Servicemitteilung zu AE 2990 AFS v. 21.2.2011

Service Note 2990 AFS issued 21. 2. 2011

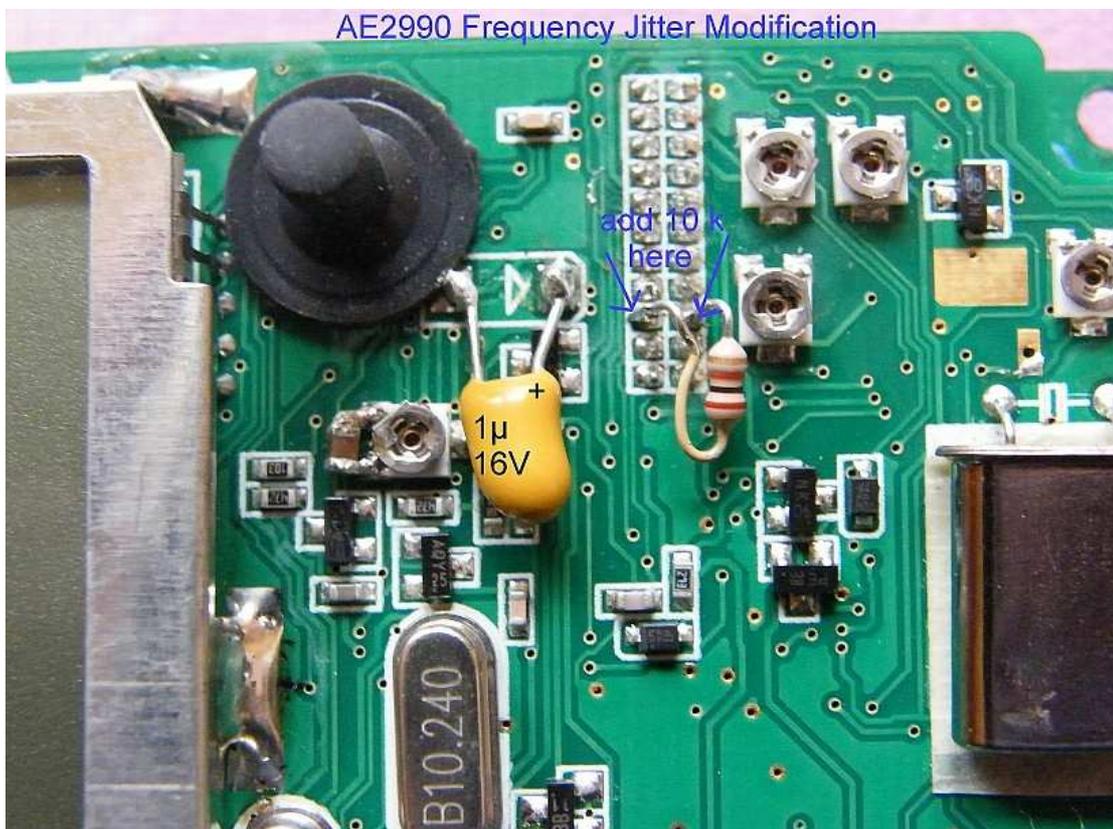
Ursache: Der Lastwechsel der ansteigenden Sendeleistung bei SSB beim ersten Sprechen bewirkt eine unerwünschte HF Rückwirkung auf den VCO. Die Phasenregelschleife erkennt das als Frequenzablage und regelt nach. Das Regelverhalten reagiert dabei kurzzeitig wie ein Überschwingen.

Users reported that units from first production lot show more or less a “frequency jitter” effect during strong SSB modulation. The problem occurs as frequency shift of about 100-200 Hz especially if users produce whistle tones into the microphone during the first 10..20 milliseconds of the tone duration. Distant stations report that the tone is not constant and becomes ok later.

Cause: A negative feedback from rising output power with SSB modulation can cause a short time frequency shift reaction of the VCO. The PLL and phase comparator circuits then try to compensate the VCO Varicap voltage.

1. Änderung eines Standard SMD Elkos von $2.2\mu\text{F}$ in einen Tantal-Elko $1\mu\text{F}$ (gelb) in der Phasenregelschleife nach obenstehendem Foto.

2. Zusätzlich kann man auch noch einen **zusätzlichen Widerstand** von ca. $10\text{ k}\Omega$ über die im Bild gezeigten Kontakte des Pfostensteckers (3. Kontaktebene von unten gerechnet, entspr. R 203) legen.

Dieser Widerstand wird aber nicht empfohlen, wenn jemand Wert auf gutes Einrasten auch im untersten und obersten der 400 Kanal-Bänder Wert legt (ggf. ausprobieren).

1. Change the original **SMD standard capacitor 2.2 µF** into a **Tantalum capacitor of 1µF** capacity (yellow on above photo)

2. Additionally the effect can be further reduced by **adding an additional resistor 10 kOhm** parallel to the PCB plug contacts of the third row (seen from bottom). (Info: these contact points connect to R 203 on main board).

Because this additional resistor may cause longer lock-in periods on lowest and highest 400 CH band frequencies, we do not recommend this modifications to users who should use this configuration. In that case we recommend to check the lock behaviour with and without resistor.
